05-004/14 - MULTI-MODEL - WHINING NOISE FROM AUTOMATIC TRANSAXLE

Subject: WHINING NOISE FROM AUTOMATIC TRANSAXLE	Bulletin No: 05-004/14
	Last Issued: 03/05/2014

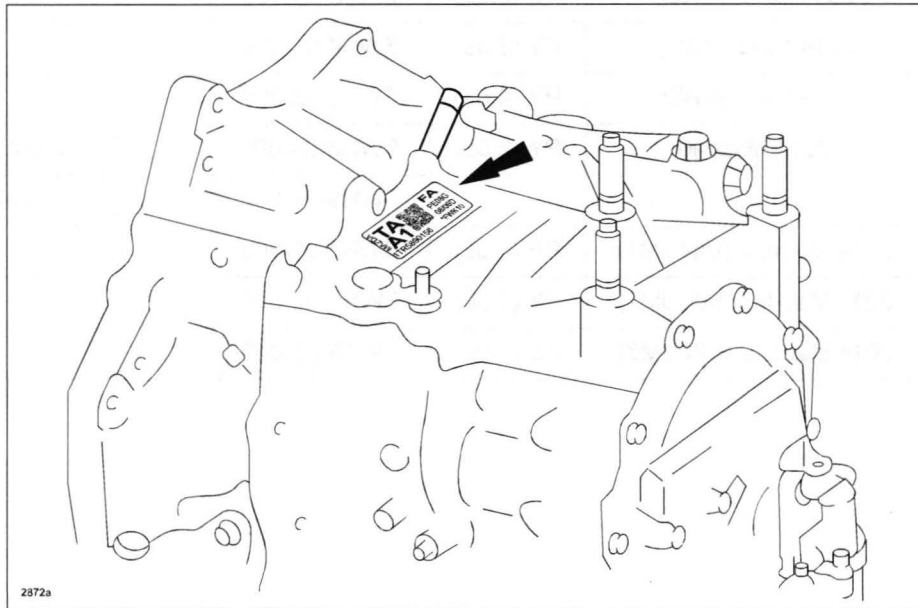
This is caused by a damaged bearing in the transaxle due to improper configuration of the transaxle case. A modification has now been implemented on automatic transaxles with the serial number TR1111680 and higher or TD1104906 and higher. The serial number can be found on top of the transaxle case near the manual shaft lever.

1. Verify customer concern.
2. Replace the 6AT assembly with a new one according to MS3 online instructions or Workshop Manual section 05-17.
3. Verify repair.
